Application for  PROJECT SITE REVIEW  SITE PLAN REVIEW-LAKEFRONT DISTRICT  
City Hall Commons - Room 500 \* 201 E. Washington Street \* Syracuse, NY 13202-1426 \* 315-448-8640

For Office Use: Filing Date: 6/1/2021 Case Number: SR-21-02 Zoning District: BA

**Re: Site Plan Review Application - Proposed Family Dollar  
3114 and 3116-30 James Street  
City of Syracuse, Onondaga County, NY**

**SK-10**

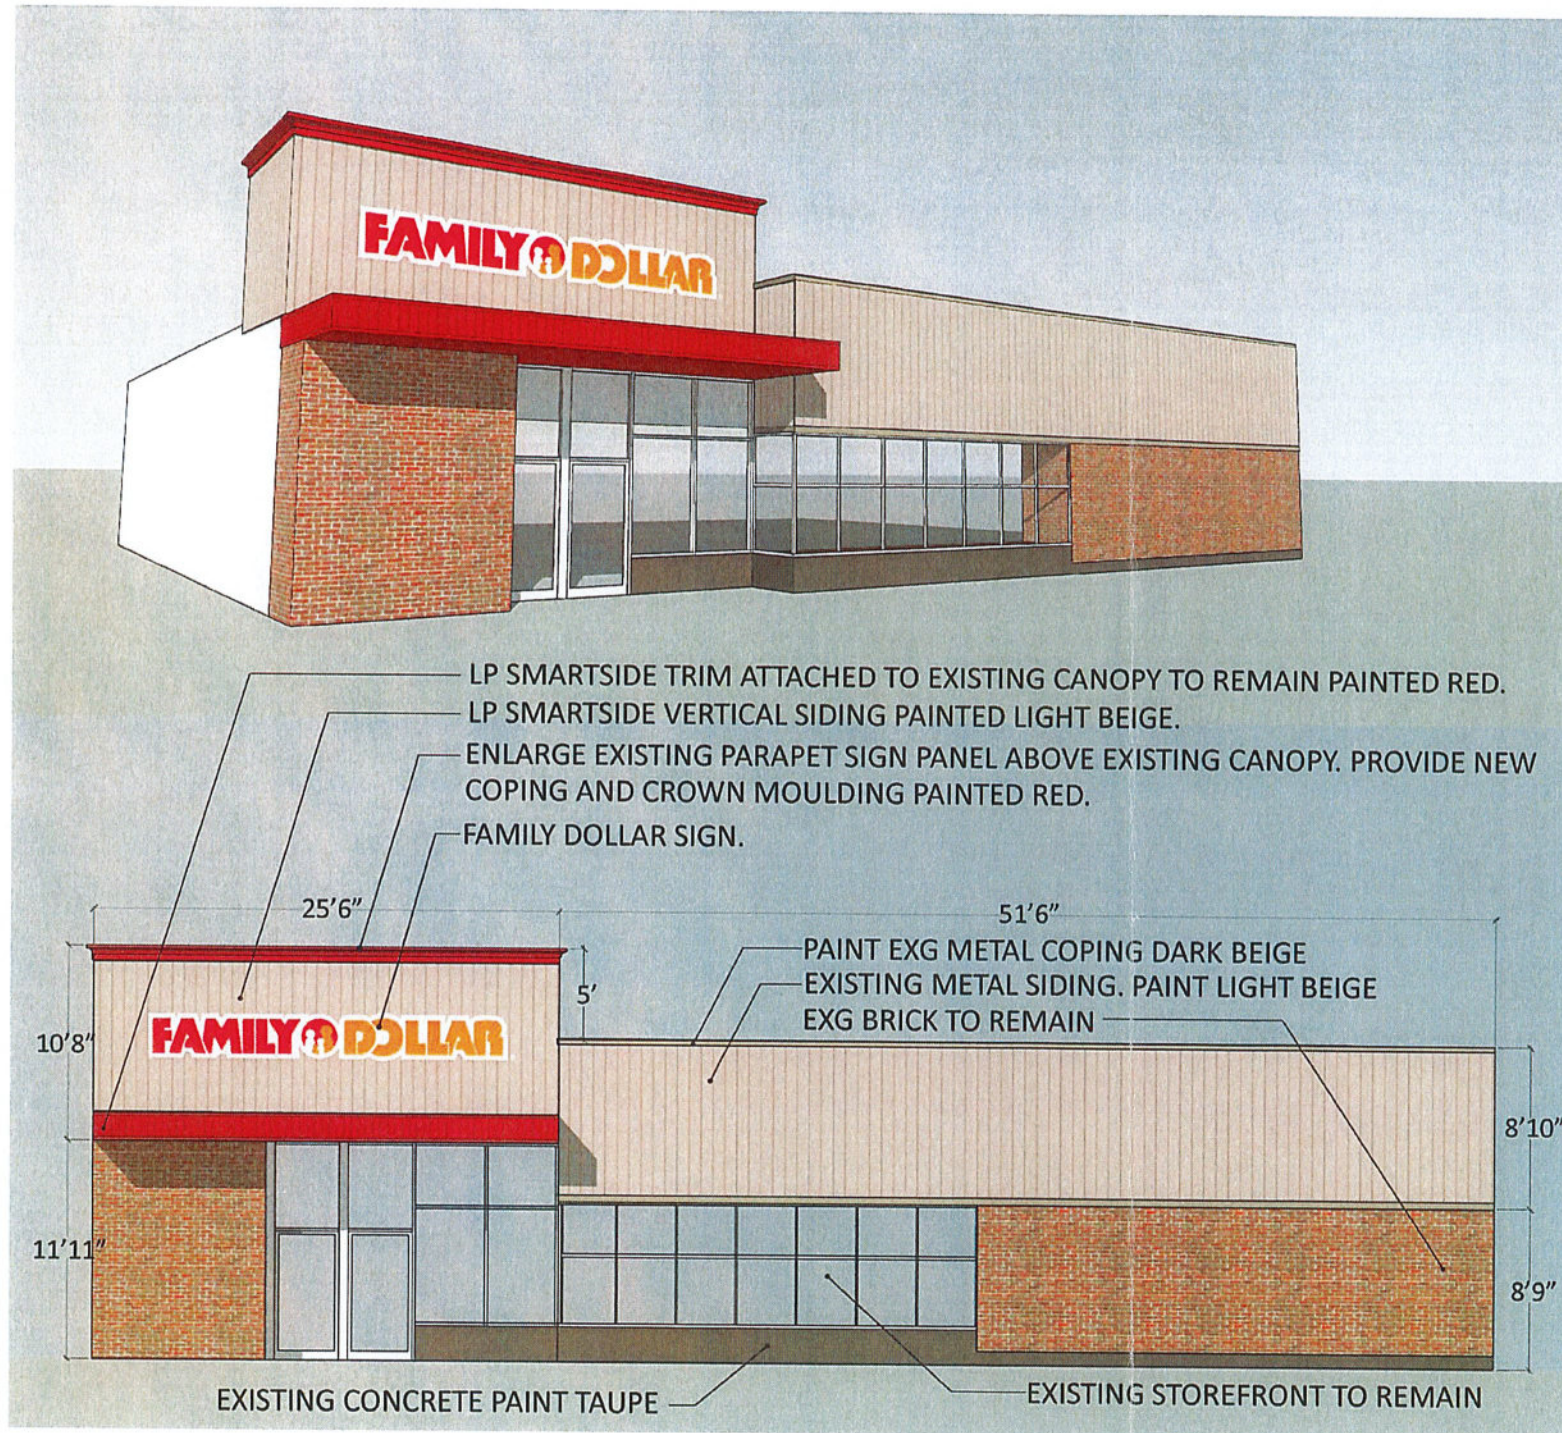
*Project zoning information has been provided in the site criteria checklist. Please note that upon review of the zoning map, it appears that the zoning district line does not match the existing lot line.*

*Two precast concrete drywells are proposed within the existing asphalt parking lots to the east and west of the existing building. Drainage arrows indicating the direction of on-site sheet flow are provided on the plan.*

*An ADA parking space and associated striping/signage is proposed at the northwest building corner. The remainder of the existing parking layout, spaces, and aisle widths are to remain as they exist today. The asphalt pavement will be resurfaced and sealed as needed with no change to the site drainage conditions.*

*A proposed dumpster enclosure and concrete pad is shown on the plan in the southwest corner of the subject property.*

- Addition of two 4' diameter precast concrete dry wells within the existing parking area.
- Proposed striping for ADA parking space on either side of the existing building.
- Drainage arrows are shown on the plan to illustrate the on-site drainage pattern across the parking lot
- Two pipe bollards are shown adjacent to the existing gas meter on the east side of the building.
- A proposed concrete pad and dumpster enclosure is located in the southwest site corner.

PROJECT NO. 20-1947  
 DATE 14 MAY 2021  
 SCALE 1"=10'  
 SHEET T-1

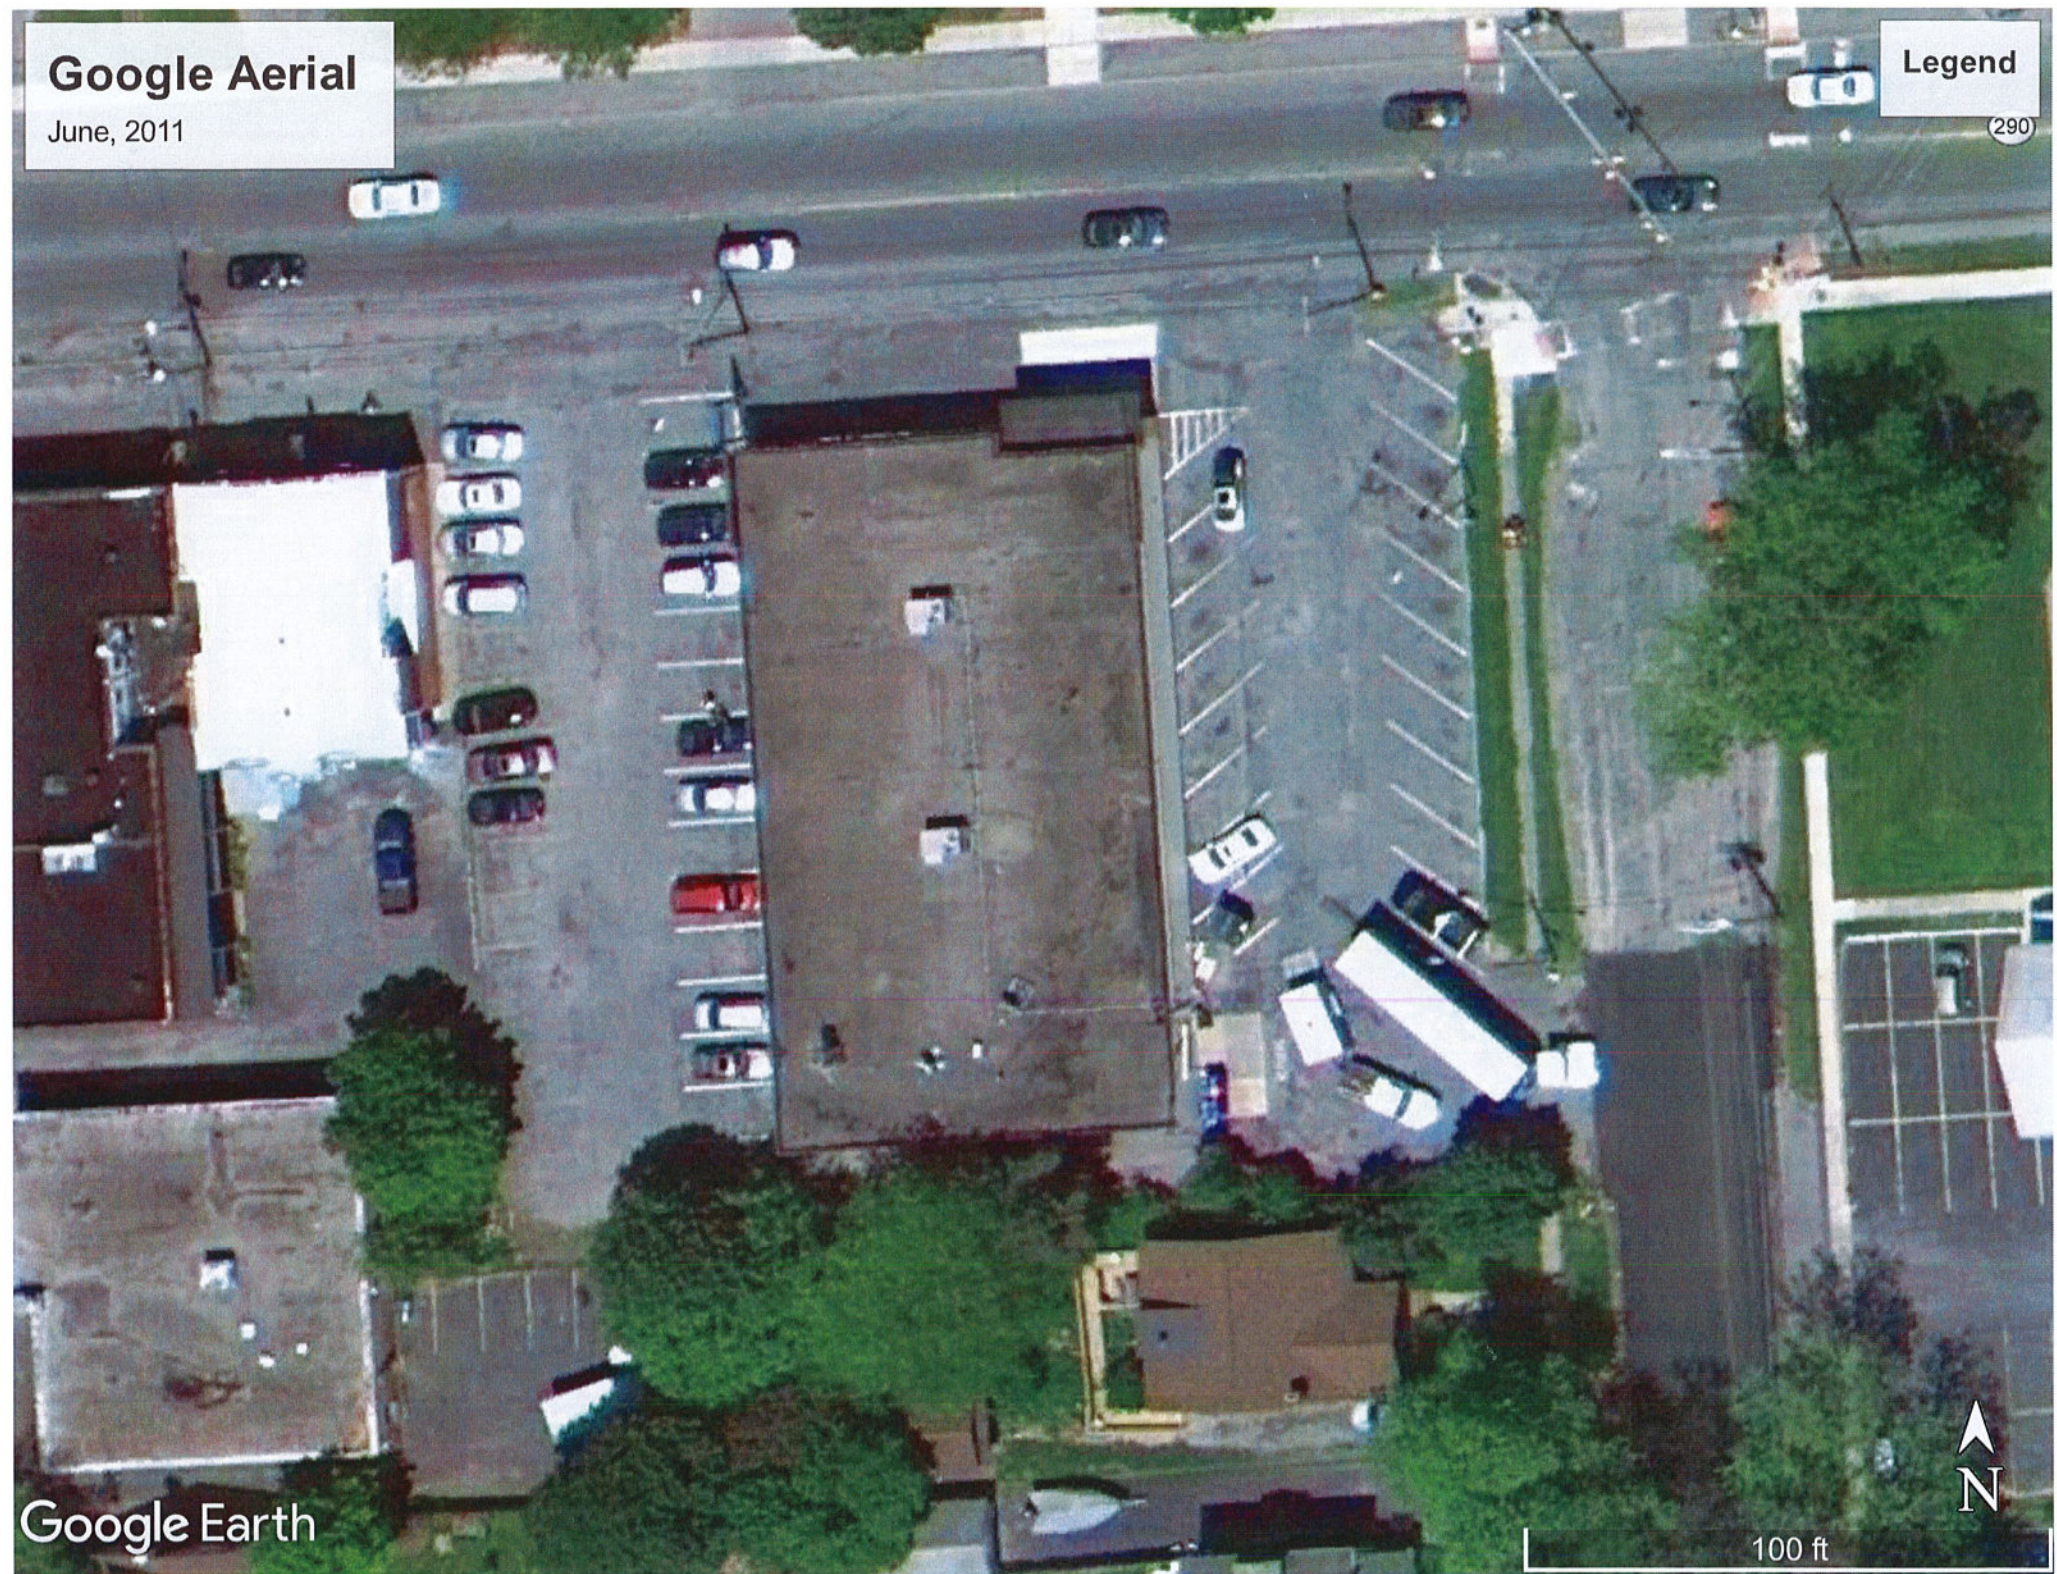
2. Family Dollar requires both curb cuts for customer, employee, and delivery ingress/egress. Per our site plan, we have demonstrated the delivery truck turning radius plans. Without both curb cuts, there is no way for the delivery truck to make the proper movements within the site. Without both road cuts there is potential to block customers and/or employees, fire trucks, etc. from ingress/egress to the site.
